Our ref: DOC22/612801
Your ref: SSI-10050

Wilcannia Weir Replacement Environmental Impact Statement exhibition

BCS's recommendations

Environmental Impact Statement – Wilcannia Weir

Figure 1: Excerpt from Figure 4-4 of Public Works Advisory (2019)² showing weir pool extent for an example section of the Darling River within the 'new town pool' compared with impact zone shapefile provided by Jacobs. FSL in this figure refers to the 'normal' operating mode of 65.71 AHD.

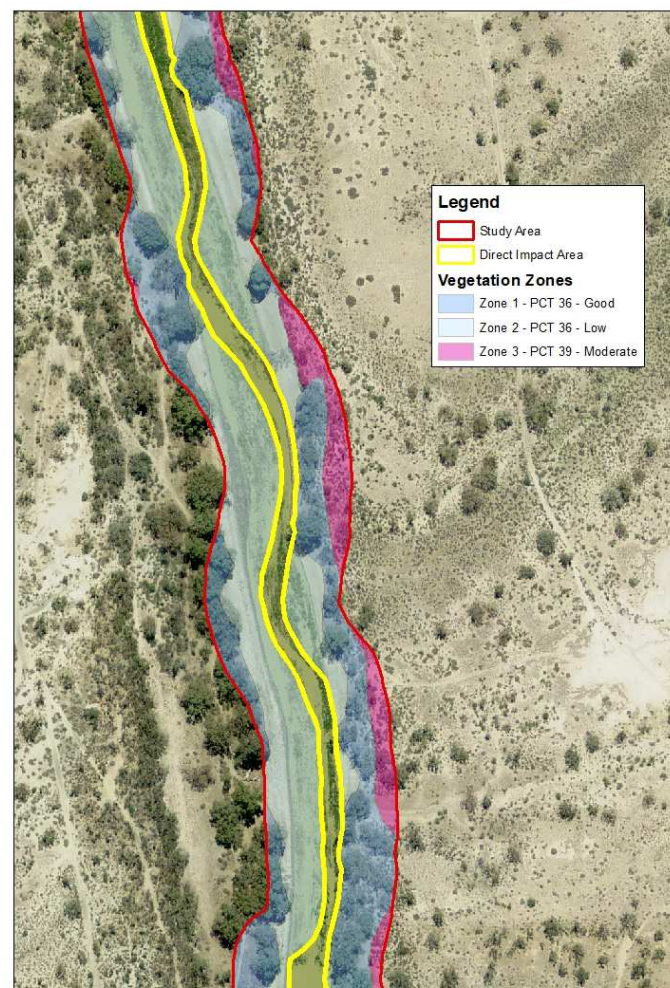
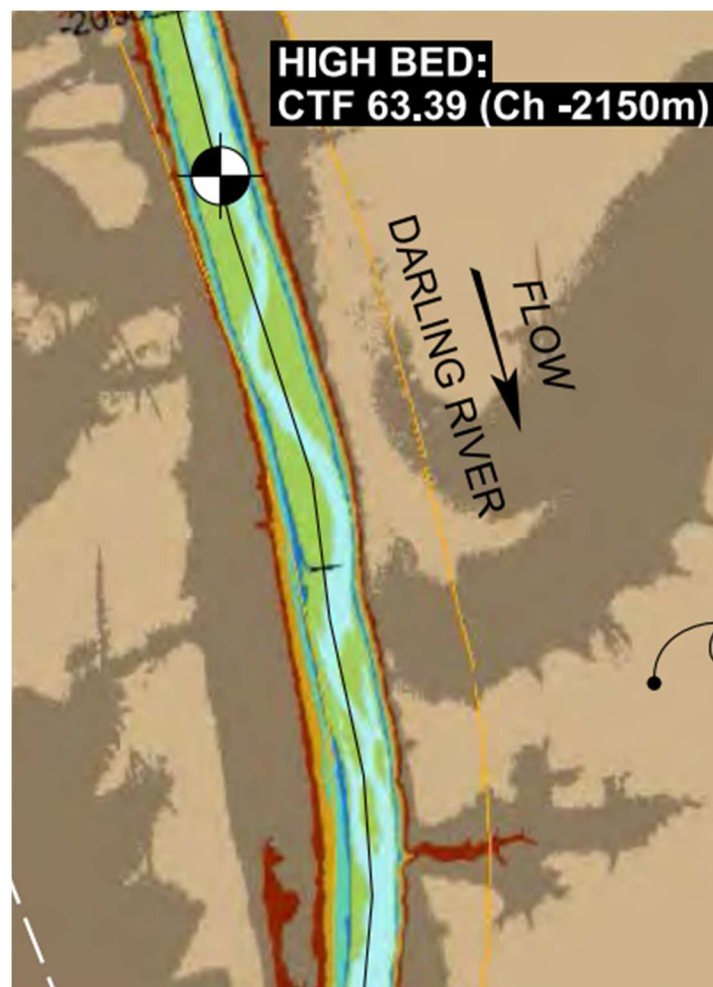
Technical Report 1 refers to weir pool extent mapping undertaken by Public Works Advisory (PWA)². Comparison of the GIS shapefile utilised to calculate the area of native vegetation impacted by inundation within the 'new town pool' against the Public Works Advisory mapping of weir pool extent² suggests that the area of native vegetation to be subject to increased inundation within the 'new town pool' has been substantially underestimated.

Figure 1 below shows an example section of the Darling River within the new town pool and allows:

- an understanding of the predicted weir pool lateral extent at the 'normal' mode FSL, although is less clear for the extent associated with the 'drought' operation mode, as the legend depicts a range from the normal FSL to two metres above, rather than one metre above.
- comparison of the weir pool extent with the area of direct impact to native vegetation associated with inundation the new town pool assessed in the BDAR and BAM-C.

Left: the extent of inundation up to the 'normal' mode FSL of 65.71m AHD (the entirety of the channel to the outer extent of the dark blue areas).

Right: the extent of the direct impact zone for inundation as assessed in the BDAR and BAM-C (the two individual 1.5 metre strips shown in yellow on either side of a channel mapped by the assessor within the river banks (GIS shapefile provided to BCS via email by Chris Tompson on 9 August 2022)).

- 3.1 Demonstrate that the area of direct impact entered into the BAM-C to account for the impact of inundation of native vegetation between the proposed and existing weirs corresponds with the expected maximum extent of inundation in the new town pool at the proposed drought security mode FSL. This should include mapping of the expected extent of inundation overlaid on the vegetation mapping.
- 3.2 Where the 'river channel' has been excluded from vegetation zones – reference the supporting information that demonstrates either:
 - a) the lack of native vegetation within that area
 - b) the lack of impact in that area from the proposed changes to inundation.
